From: [REDACTED]
Sent: 04 February 2026 16:45
To: Anna Tidey
Cc: Emily Wade
Subject: Re: DM/25/2840 - Windows for Chilcotts, Whitemans Green, Cuckfield.

Subject: Re: FW: DM/25/2840 - Windows and rainwater goods for Chilcotts, Whitemans Green, Cuckfield.

Subject: Re: Recommendation for DM/25/2840 - Chilcotts, Whitemans Green, Cuckfield.

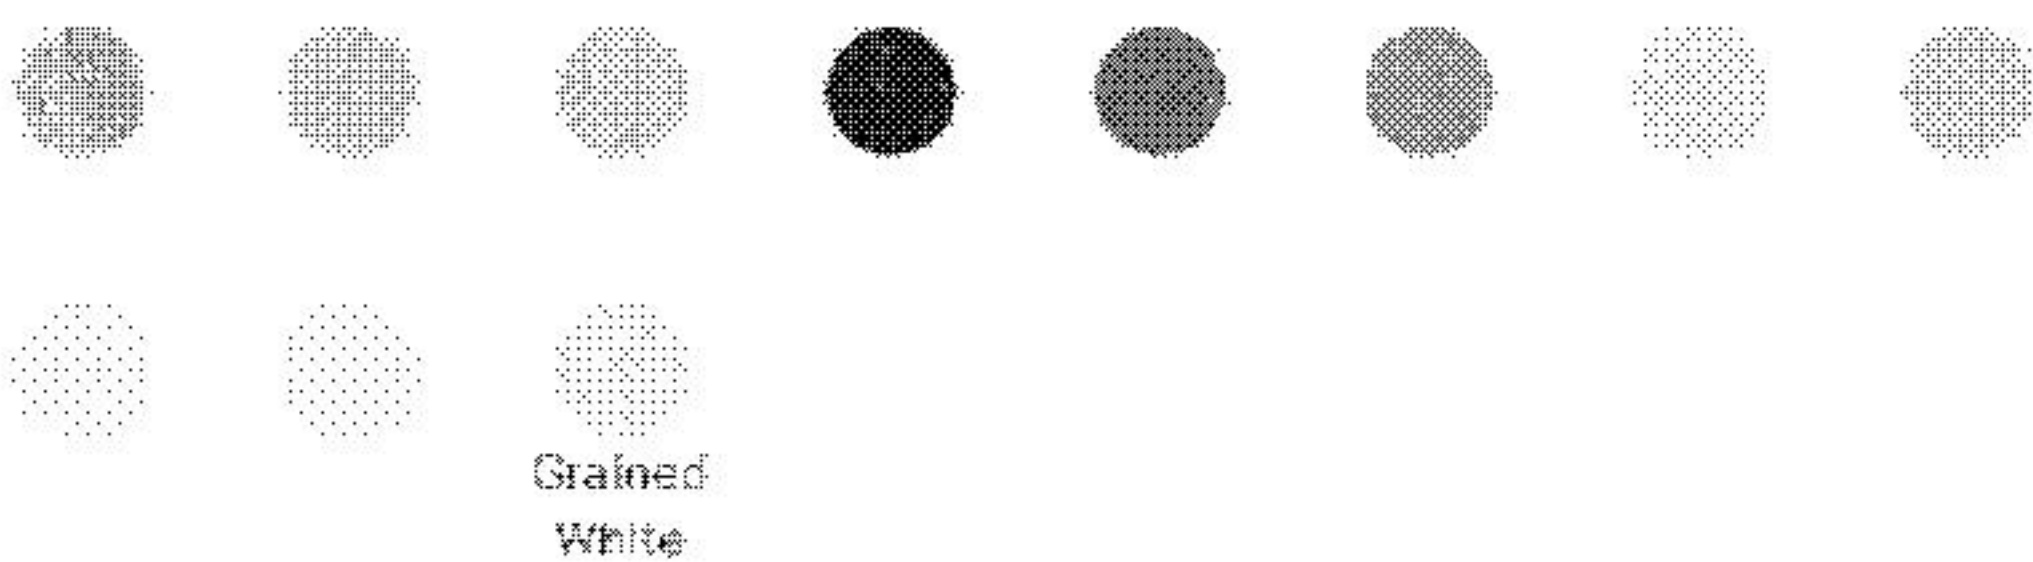
Sorry, I though we had discussed the grey/green Painswick option, as your preferred colour choice?

I have reviewed the R9 colours (see link to brochure below) and there is no ‘Clay’ colour option?

Yes, we absolutely had discussed the grey/green Painswick option as our preferred colour choice, but, having visited BSF today and collected the latest R9 brochure, my wife has changed her mind since our conversation and is opting for Clay. Before delivering to your offices (marked FAO Emily), I enclosed a hard copy of the latest brochure with the window sample and marked the colour swatch page for Emily to easily access. Apologies for the confusion/last minute change.

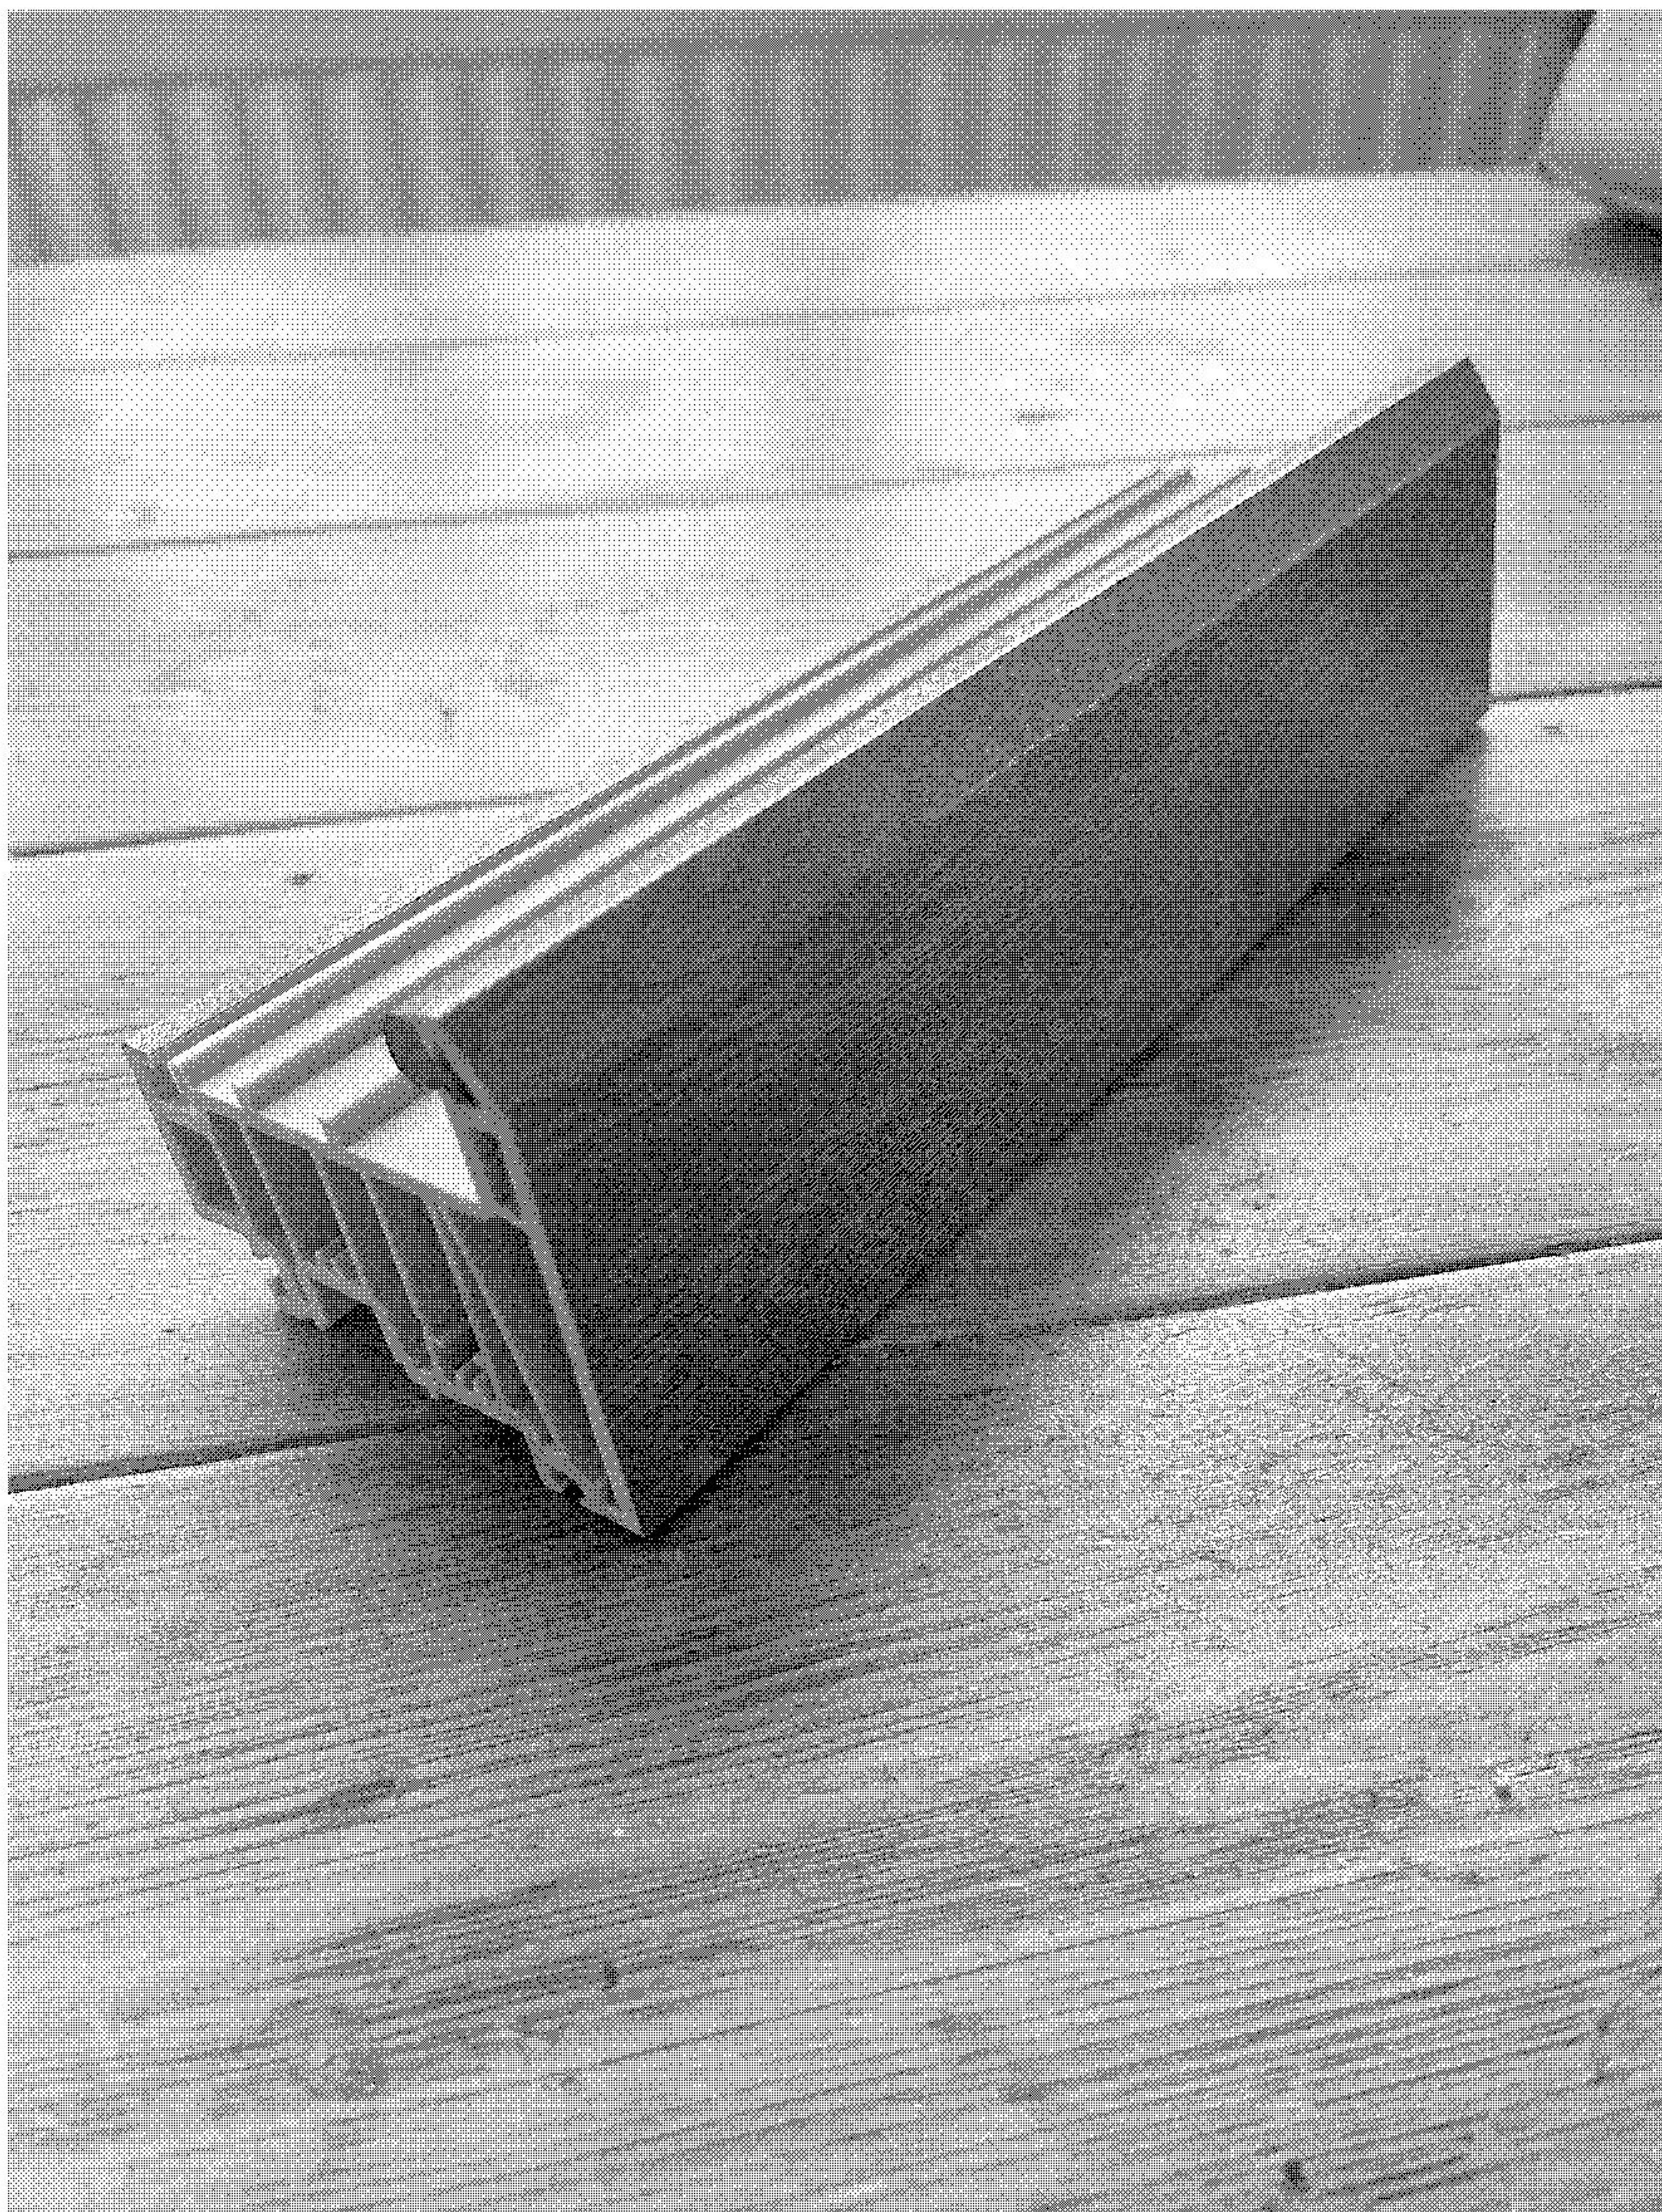
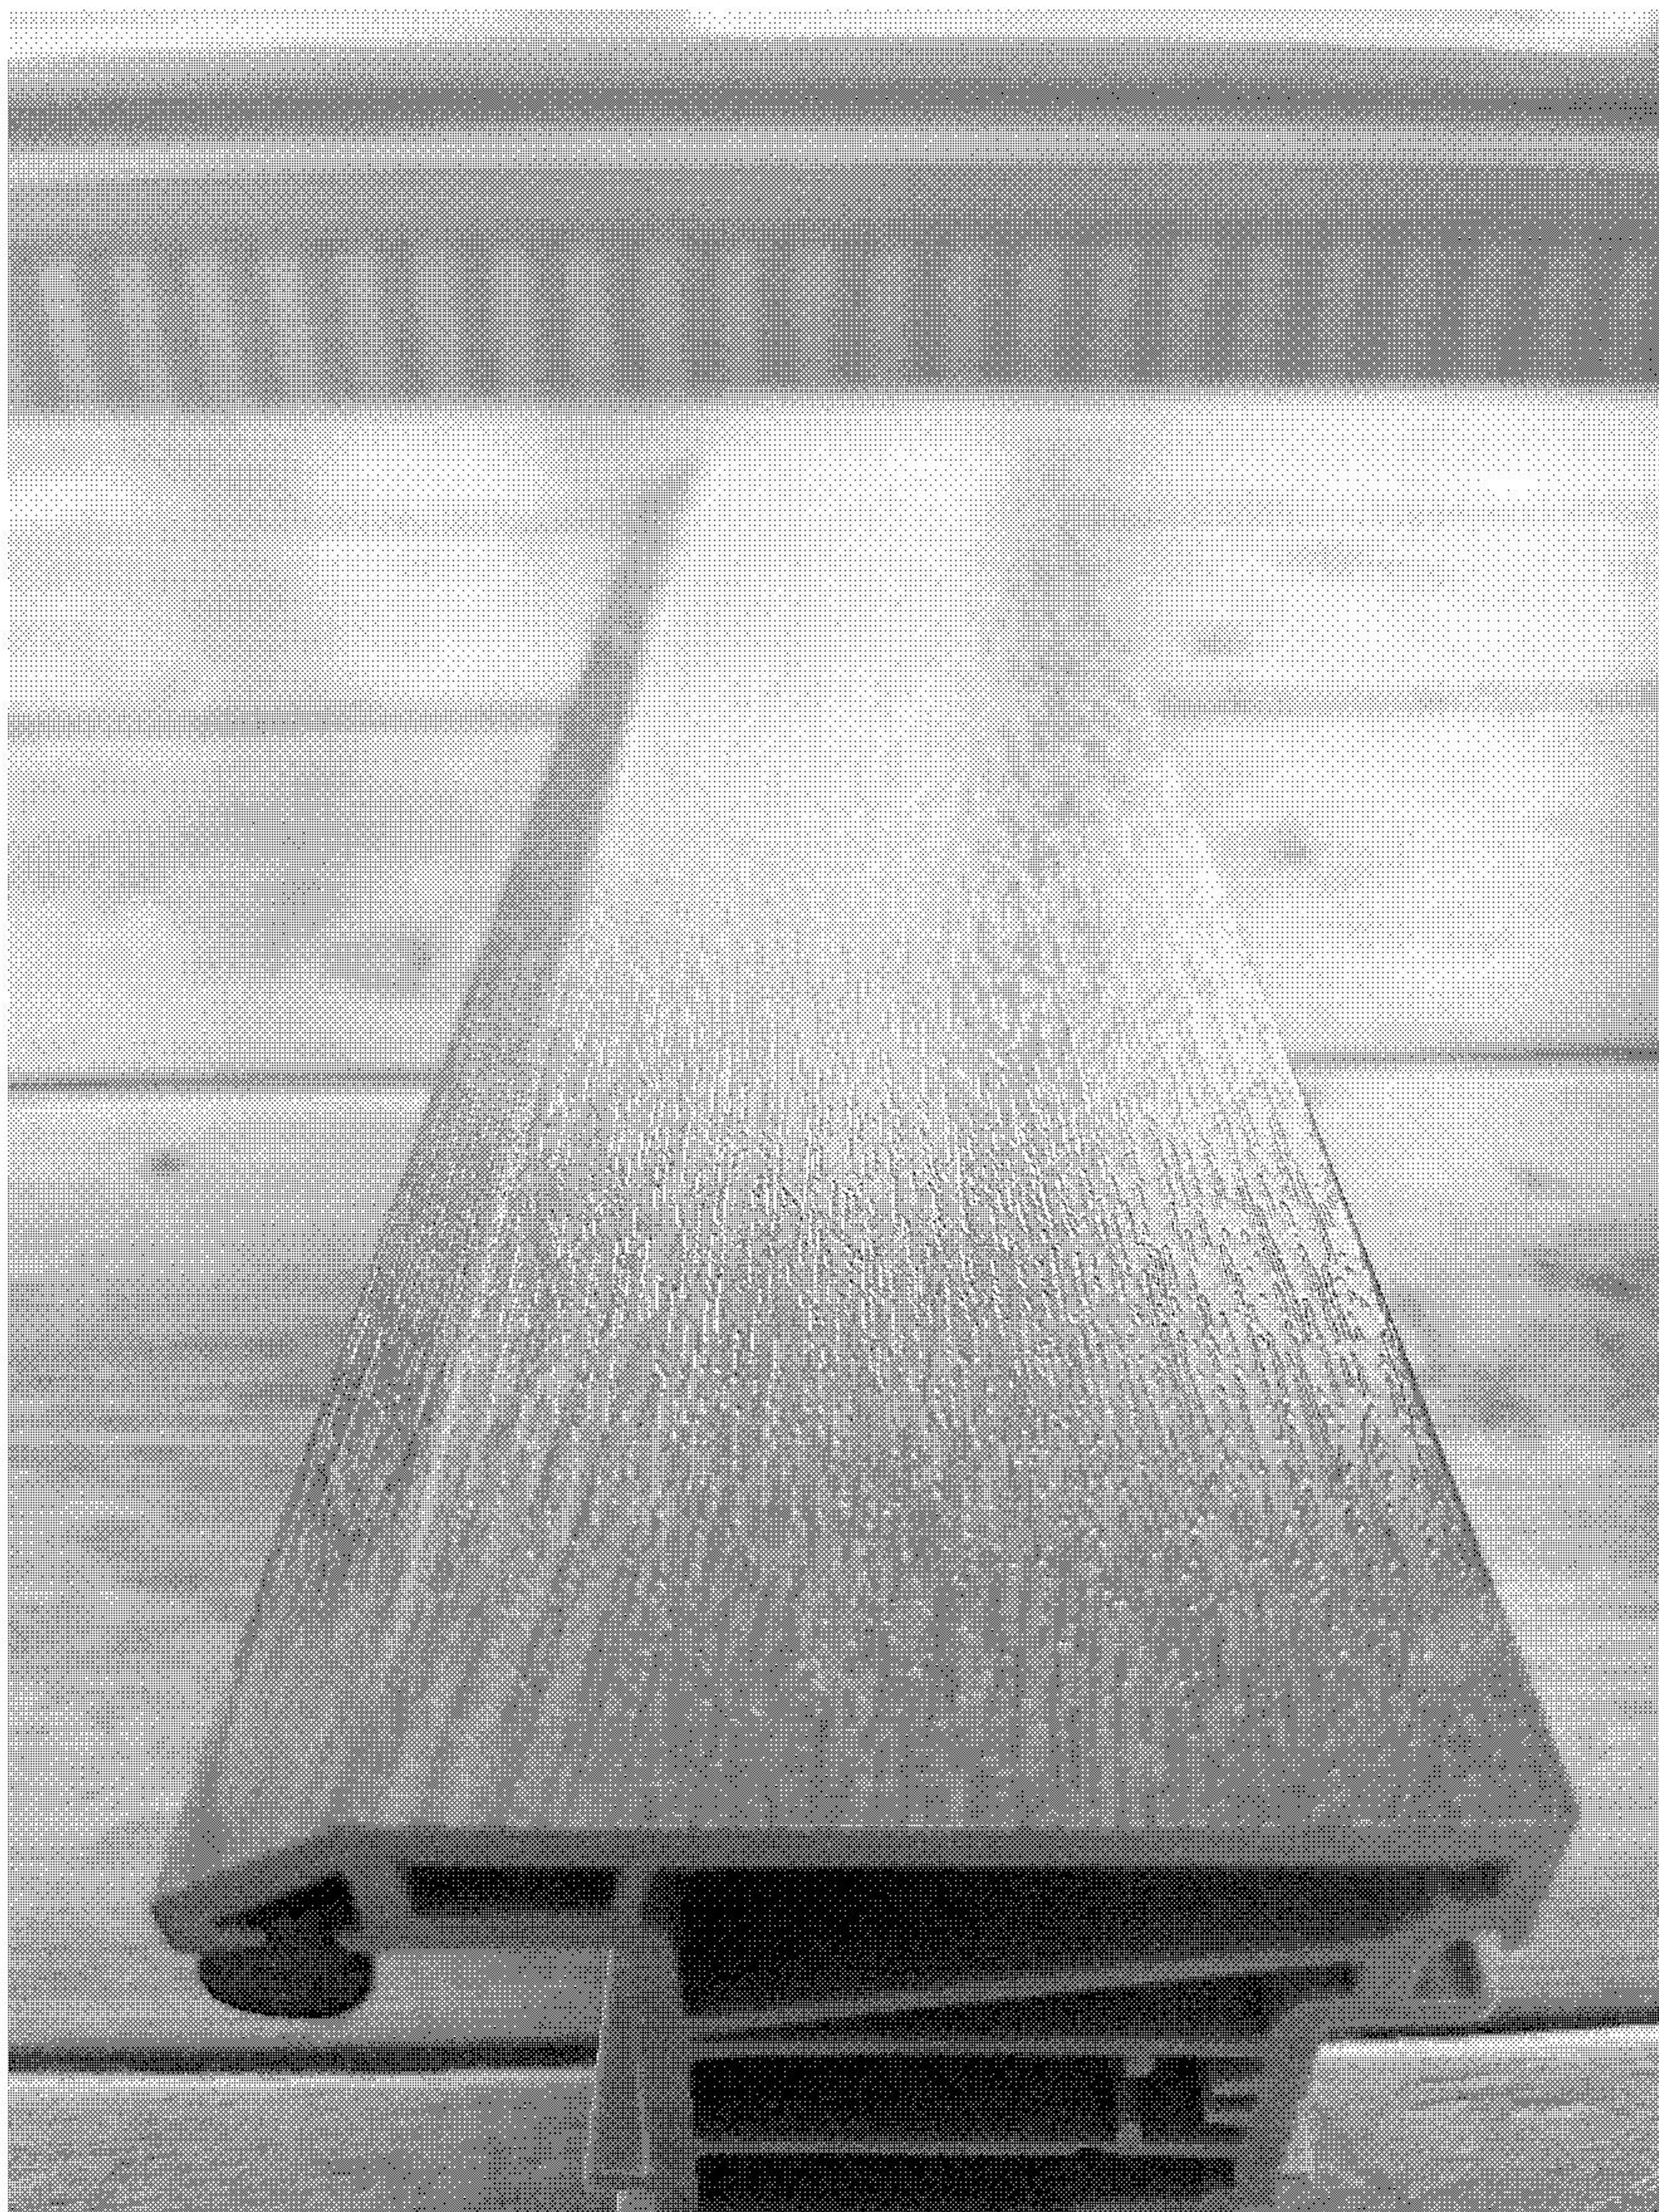
Good to talk to you earlier. To confirm, our request is to go with Residence9 windows in "**CLAY**" - a change from what I originally specified.

The only sample we can get hold of is the correct material and grain in the English Oak colour, as below;
